Redesign of Gatwick Route 4 RNAV SIDs

Stage 2 Design Engagement Document

CAA Ref: ACP-2018-86

Reference	Description
Document Title	Redesign of Gatwick Route 4 RNAV SIDs
	Stage 2 Design Engagement Document
Document Ref	71248 072
Issue	Submission 2 Issue
Date	15 July 2022
Client Name	London Gatwick Airport
Classification	Commercial in Confidence until Release

Figure 8 Option 7 – Constant Radius to Fix (Tracks Concentrated)

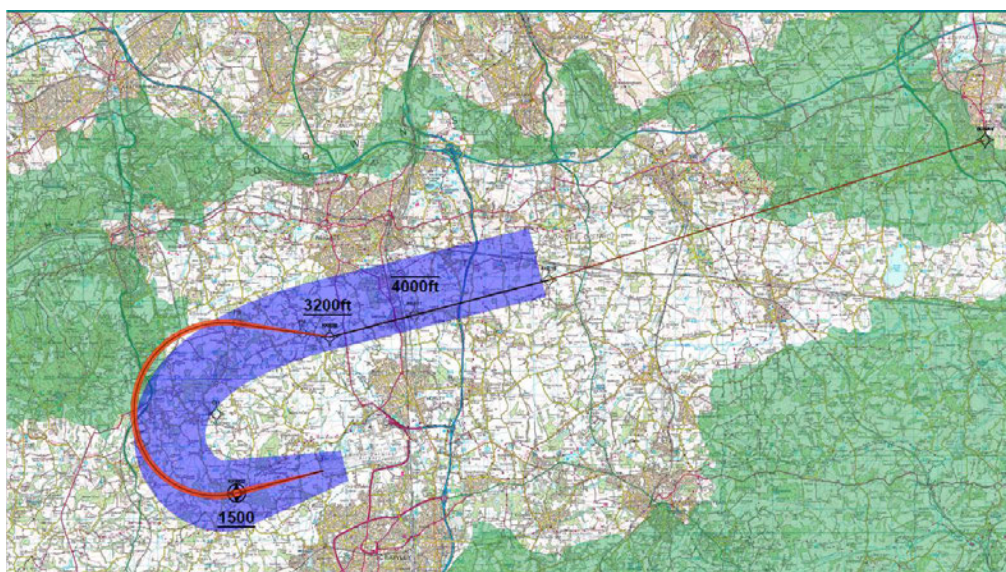
be an adverse impact on the Surrey Hills AONB and a local school while also naming villages that would be overflowed that are not at present.
	Betchworth Parish Council	In the opinion of the Betchworth Parish Council representative, Option 7 New does not facilitate dispersion and further concentrates outbound traffic adding that the route lies outside the existing NPR, expressing additional concerns regarding movement of the NPR. Additional points are raised regarding the Surrey Hills AONB along with the proximity to Route 3.
	Reigate and Banstead Borough Council	In their response, Reigate and Banstead Borough Council believe that the route options presented restrict dispersion, having a greater impact on noise receptors on the ground adding that it is believed more houses would be overflowed. The response expresses specific concerns regarding increased power settings (and therefore noise) required to complete the turns within Option 7 New. Reigate and Banstead Borough Council have expressed interest in receiving the detailed shape files of each option to identify the noise impacts in more detail and goes further to ask about how this will be impacted by the GAL Northern Runway project.

Tandridge District Council	Tandridge District Council commented that the new proposed Option 7 may cause “detrimental harm to the communities that this route option could fly over than previously seen”. The council states that they remain concerned about the impact of noise and air quality on local residents and businesses. In addition, it is requested that the routes and content is simplified to aid understanding by the public.
	Plane Justice	Plane Justice believe that Option 7 New is more concentrated that therefore allows for very limited dispersion adding that they believe that this new route “bears no resemblance to the historic routings”. It is believed that the new proposed route would overfly more residential areas specifically naming a large new housing development. Additionally, Plane Justice state that they believe the new proposed route does not seek to minimise the impact of noise on any sensitive locations, specifically mentioning the Surrey Hills AONB. In their response, Plane Justice provide a detailed breakdown of specific pages within previous and recent documentation. An example, being reference to Option 0 shown as the “unlawful” flight patterns presented in 2016. Plane Justice conclude by highlighting that they believe the issues identified as part of the ACP Statement of Need should be considered as part of the proposed designs.

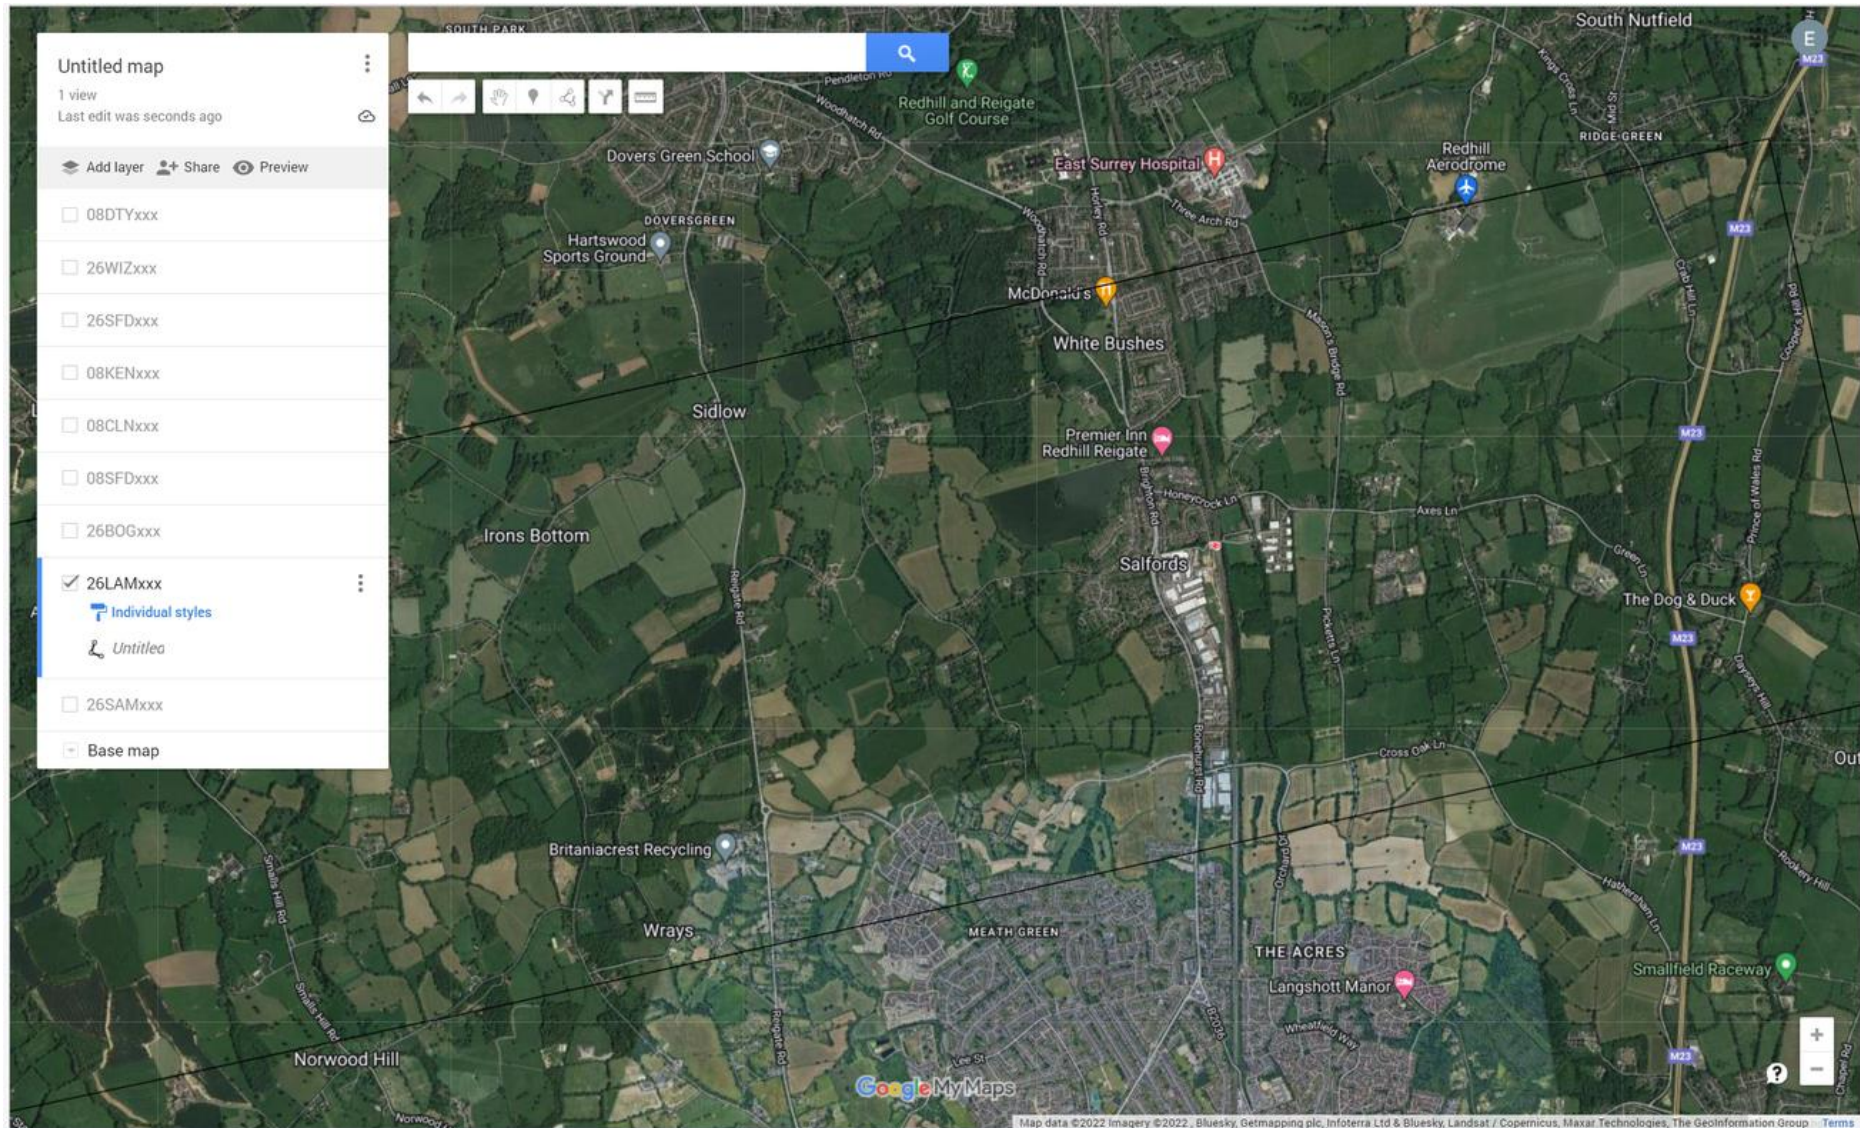
[REDACTED]
On 18th March the Route 4 ACP team circulated a set of charts with the Route 4 options including a depiction of the NPR swathe. In the Plane Wrong response we pointed out that the NPR swathe as shown is in error by approx 1000m. I have not had any response and I am not sure how long it will take for the stakeholder responses to be reviewed, so I thought it prudent to contact you directly. If the option charts circulated for comment are showing the NPR in the incorrect position that clearly has a major effect on the validity of the responses.

In 2019, in response to an FOI request, the CAA gave Plane Wrong copies of the latitude / longitude coordinates of the Gatwick NPRs along with KML files in order to plot these accurately on digital maps. I have attached a number of screenshots to show the differences between the historic position of the NPRs, and that depicted on the Route 4 options charts. Those annotated KML are the historic position, using the CAA files, which is identical to that shown on WebTrak and all GAL noise publications. Those annotated ACP are the positions used in the Route 4 ACP options charts.

The CAA can confirm that the Route 4 Noise preferential Route (NPR) as described in the currently promulgated UK AIP EGKK AD 2.21 Noise Abatement Procedures dated 1 November 2021, "Straight ahead until I-WW DME 2.3 then turn right to intercept DET VOR RDL258 by DET DME 31 to DET DME 15" is correct. Other communications suggesting that there is another source of definitive information regarding the NPR are incorrect.
